**OHIO TURNPIKE AND
INFRASTRUCTURE COMMISSION**

ADDENDUM NO. 1

**PROJECT NO. 25-16-01
REPAIRS AND RESURFACING
OSHP POST 90 PARKING LOT
MILEPOST 118.50
ERIE COUNTY, OHIO**

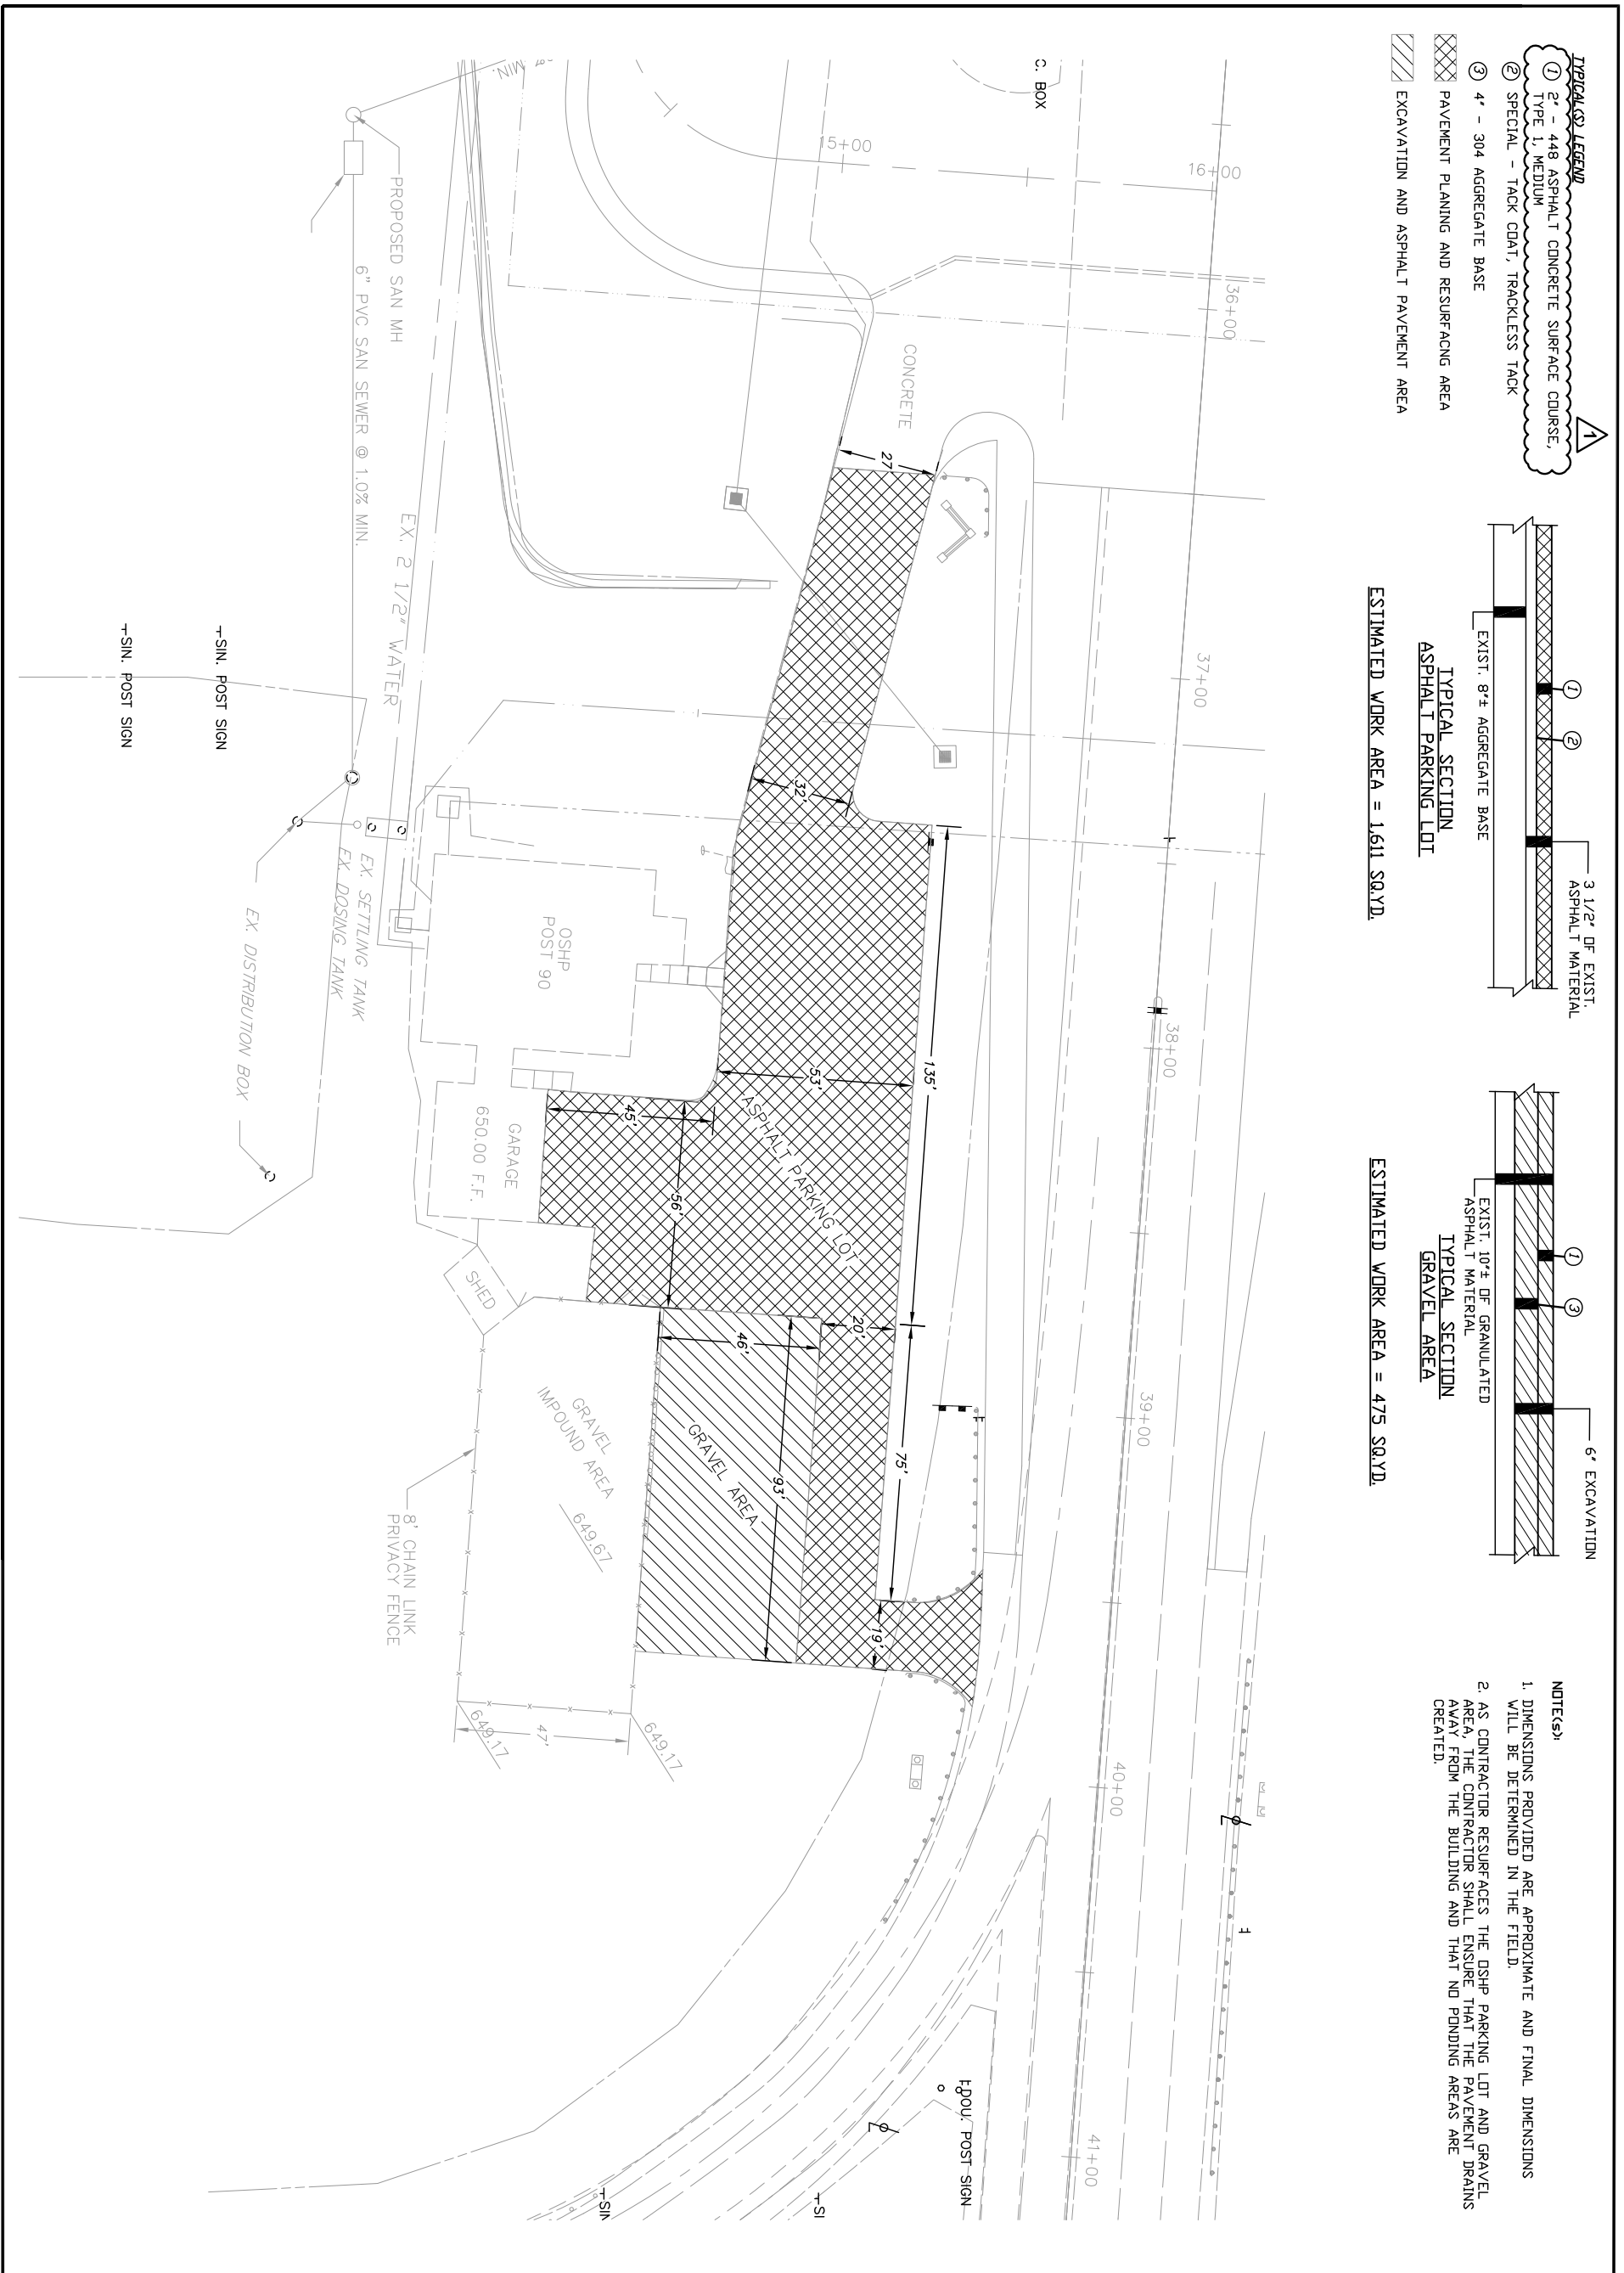
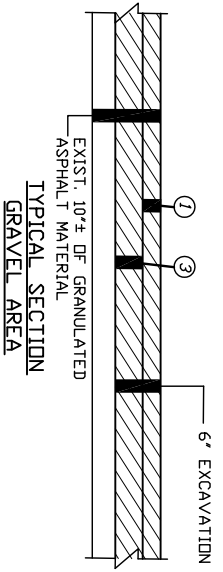
Q#1 On Sheet 2/3 the typical(s) legend shows #1 item as a 2.0" – 448 Asphalt Concrete Intermediate Course, TY 2, Medium, but the proposal (on website) has a bid item for 448 AC Surface Course, TY 1, medium. Which is correct? Is the intent to use pg64-22 liquid?

A#1 The Contractor shall supply a 448 Asphalt Concrete Surface Course, Type 1 Medium using a PG64-22 binder. This Addendum No. 1 modifies Plan Sheet 2 of 3 to correct the Typical(s) Legend accordingly. The revised Plan Sheet is incorporated into the Contract Documents with this Addendum No. 1.

- TYPICALS LEGEND**
- ① 2" - 448 ASPHALT CONCRETE SURFACE COURSE, TYPE 1, MEDIUM
 - ② SPECIAL - TACK COAT, TRACKLESS TACK
 - ③ 4" - 304 AGGREGATE BASE
- ▨ PAVEMENT PLANING AND RESURFACING AREA
- ▧ EXCAVATION AND ASPHALT PAVEMENT AREA
